- Subject** ➤ Addition of tapped hole on vise arm
- For Models** ➤ LS1011 (255mm Slide Compound Saw), LS1030 (255mm Miter Saw) and LS 1211 (305mm Slide Compound Saw)
- Note** ➤ This information applies to all countries except U.S.A and Canada.
- Description** ➤ As illustrated below, vise arm has been changed to fix thumb screw from either side of vise arm.

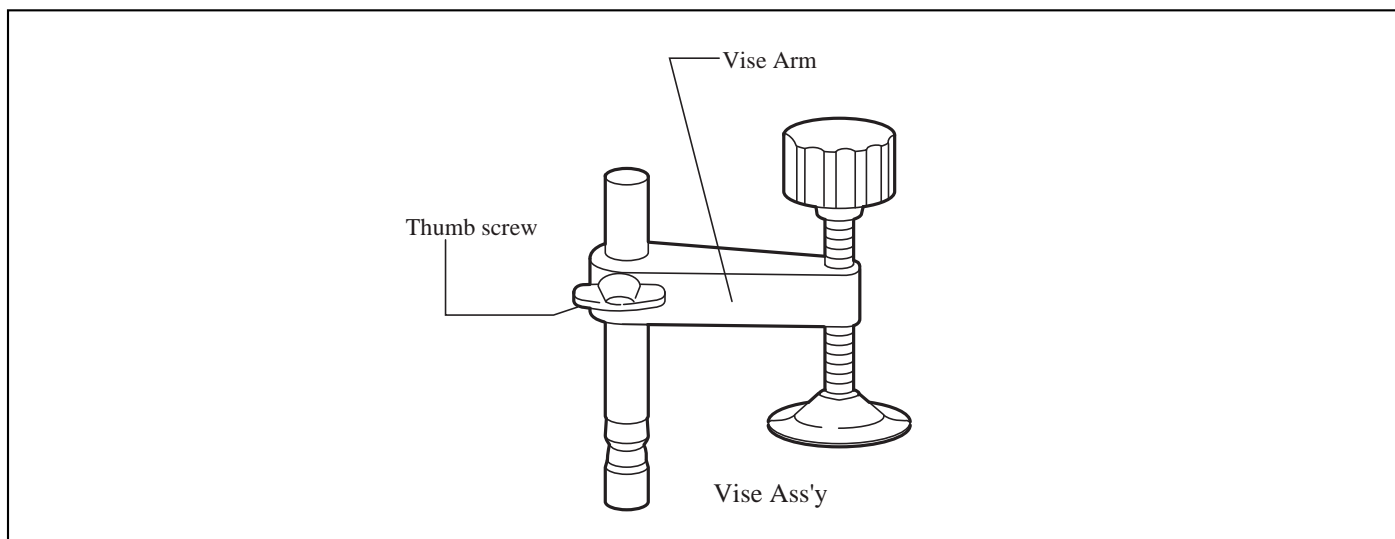
► Current	► New
Vise Arm		 <p>Tapped hole (M6) is added.</p>
